LOCATION
Manor Farm
Graveley

PROJECT NUMBER
BH23023

INTRODUCTION & BRIEF

This 'Design and Heritage' statement has been prepared by Benchmark Architects in support of a planning application for Grade II Listed home Manor Farm, Graveley formerly known as Chesfield Manor.

Outbuildings - Elevations

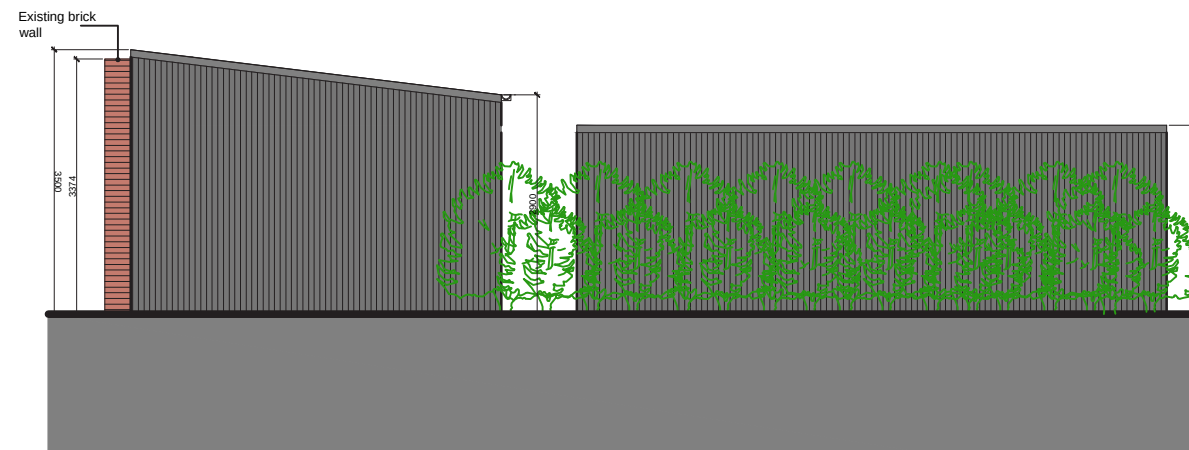
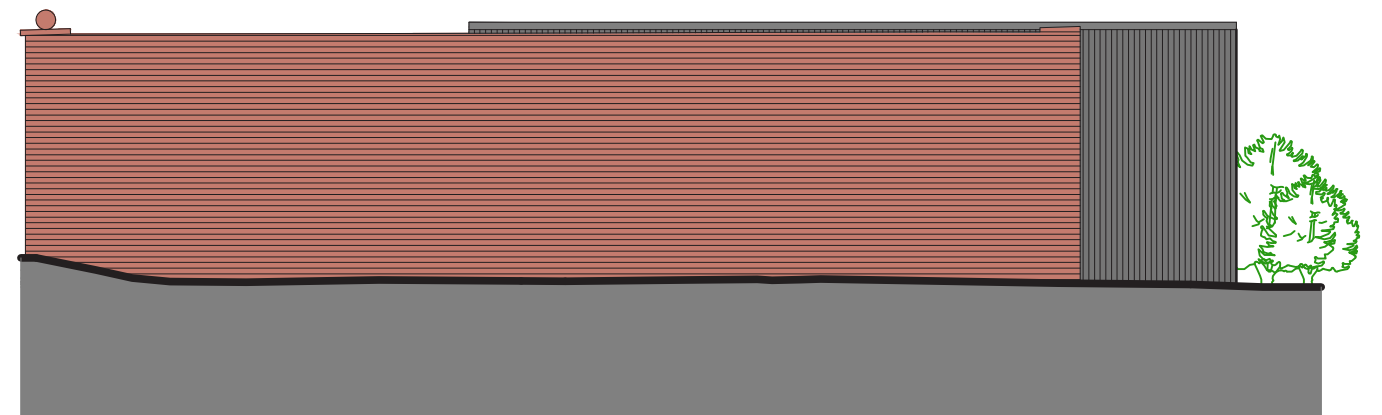
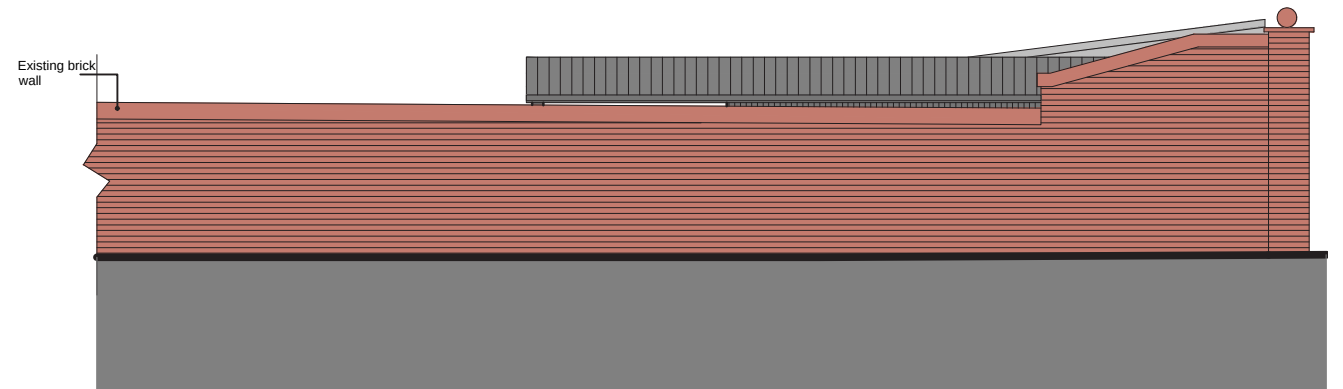
5. On a further point, the new build is that much deeper when compared with existing in which case I envisaged one of the three things happening.
 - Option 1 - Raising the height of the listed wall to screen the mono-pitched roof (not to be encouraged but I acknowledge that this wall was repaired previously).
 - Option 2 - Introducing an over sailing roof feature similar to an approved scheme that the architect is aware of elsewhere. This would be visible from outside of the site and I am reluctant to support this approach.
 - Option 3 - Maintaining the height of the wall but perhaps setting the eaves lower down which may require the internal and/or external ground level to be lowered.

6. The proposed depth of this building, therefore, has practical repercussions. In short, if a replacement building is to be successful here then I believe the design should be revisited to create a building that is more traditional in appearance, thus more respectful to its context.

The design proposal maintains the height of the existing brick wall. However the lowest existing level of (139.61m above datum level) is maintained through the entire ground floor of the outbuildings. In doing so the roof of the outbuildings does not project above the highest level of the existing brick wall significantly. A comparison of the heights of existing brick garden wall and the roof of the proposed outbuildings is shown in the elevations on the following pages.

We feel contemporary out buildings in appearance will sit well in the garden space and complement the newly proposed extension of the main house, maintaining a connection between the two parts of the Manor Farmhouse.

Gate to driveway

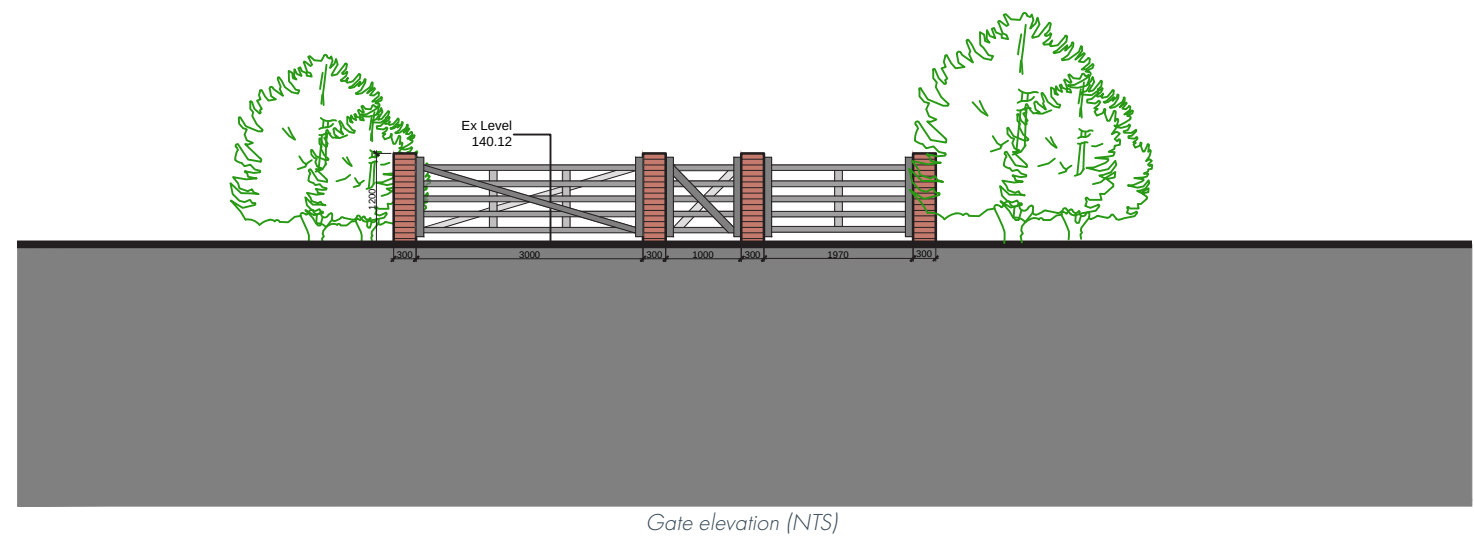
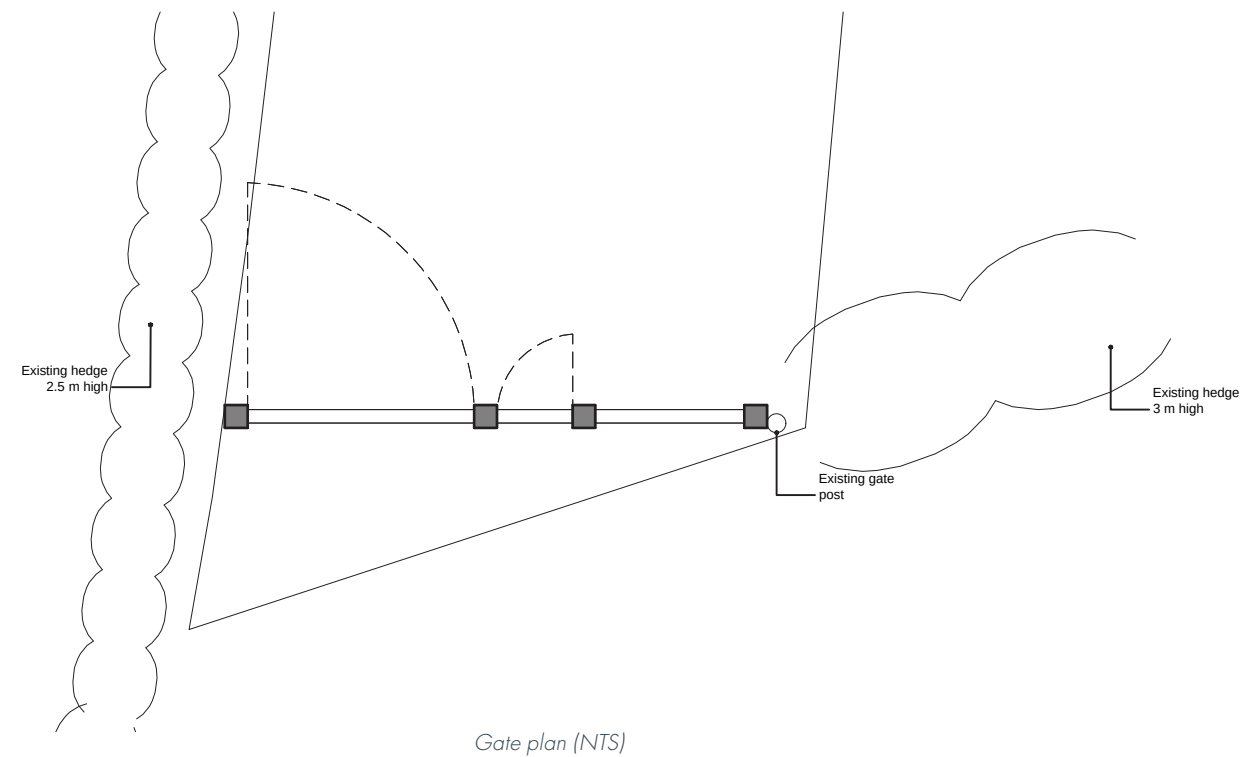
1. Unobjectionable but requiring planning permission.
The design proposal includes a gate to the driveway. Please see the following pages for the plan and elevation of the gate.

The adjacent drawings show the proposed design for the gate to the drive way. The gate will be a simple farm gate design with brick post at the ends and in between.
